June 3, 1982

Docket 70-36

ADDITIONAL ENVIRONMENTAL INFORMATION

LICENSE SNM-33 RENEWAL

Figure 4-1
Exhaust Stack Locations
for Hematite Facility

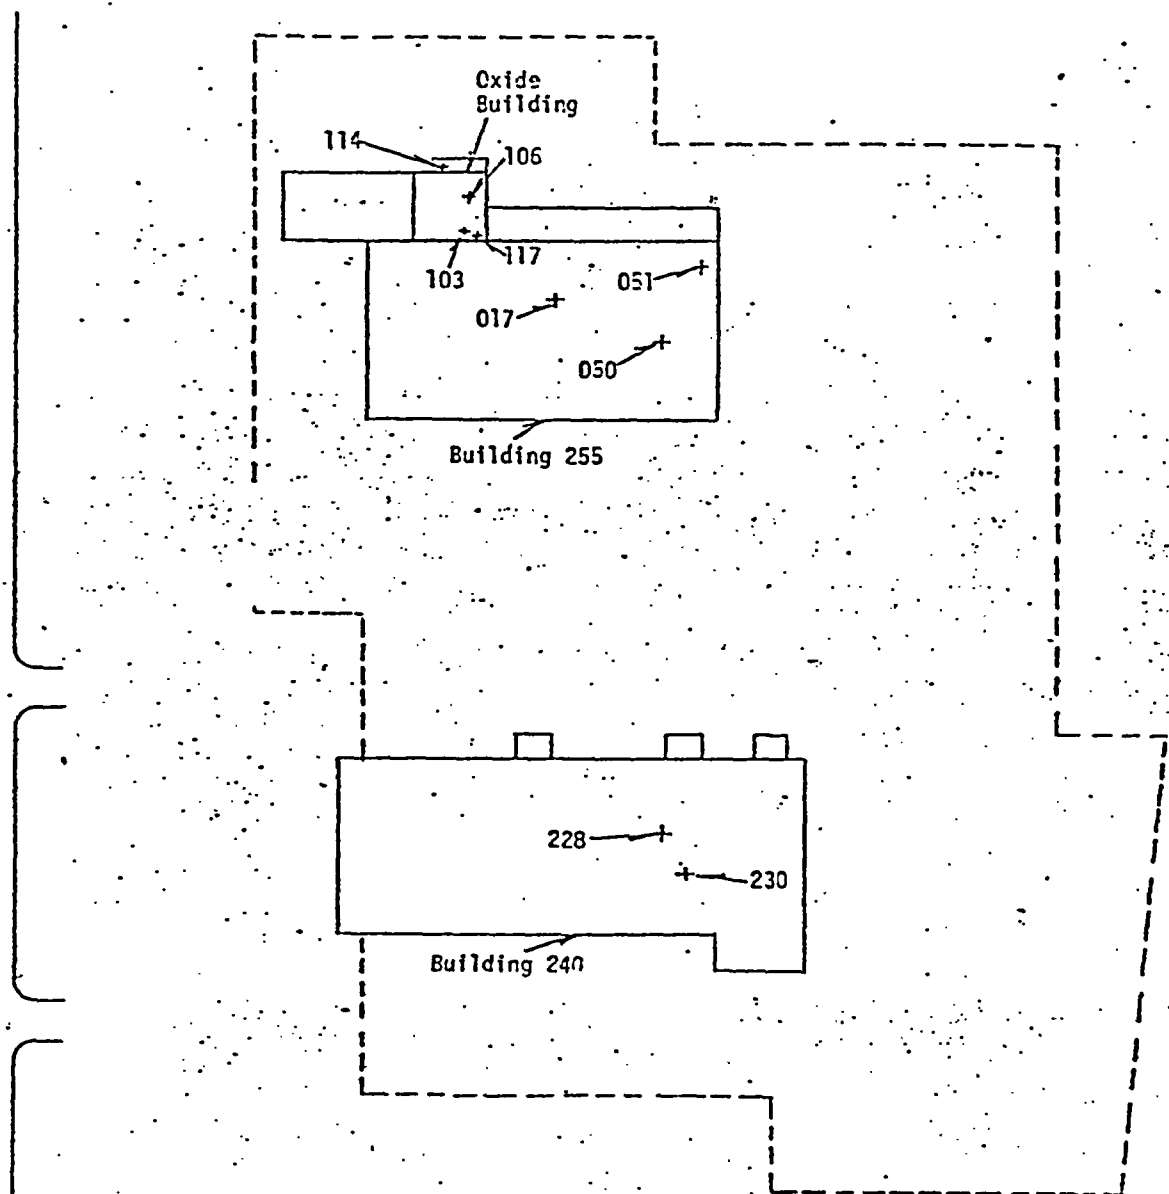
2. The configuration of the existing ventilation system is:

<u>Stack No.</u>	<u>Equipment/Area</u>
103	Filter cleanout hood Milling hood Powder unloading hoods Blender exhausts
106	3rd floor utility hood UO ₂ cooler Back-up filter hopper vents Various spot-ventilation hoses 1st floor utility hood

<u>Stack No.</u>	<u>Equipment/Area</u>
114	Dry scrubbers
117	Oxide Building room air
017	Pellet Plant room air
050	Milling hood Utility hood Office vent Consolidation hood Evaporation hood and drying ovens House central vacuum system Silo filter exhausts
051	Press fines hood Central vacuum systems Agglomeration station Grinder and centrifuge hoods
228	Pyrohydrolysis furnaces Furnace box coolers Load-unload hood Lid removal plenum Weigh and sample hood Filtrate and scrubber solution tanks
230	Solution make-up tank UO ₄ filter hood Centrifuge UO ₄ dryer and discharge hood UO ₄ precipitation and overflow tanks UO ₄ dryer scrubber Blend tank Utility hoods Dissolution vessels Slurry make-up hood ADU precipitation tank and filter press hood Acid insolubles filter press hood Filter cut-up hood Incinerator scrubber and central vacuum

Exhaust stack locations are shown in Figure 4-1.

4. The distance from stack 114 to the North Onsite Monitoring Site is 138 meters.
5. The nearest cattle grazing area is adjacent to the east site boundary, as shown in the attached drawing. Vegetation at this boundary will be monitored for fluoride during the grazing season. Initial monitoring at this location gave a range of less than 2 to 3 ppm for 4 samples.
6. Environmental monitoring at background levels occasionally results in abnormal numbers which we believe due to laboratory contamination. For example, the aquifer serving the plant well could not physically be contaminated one month and not the next.
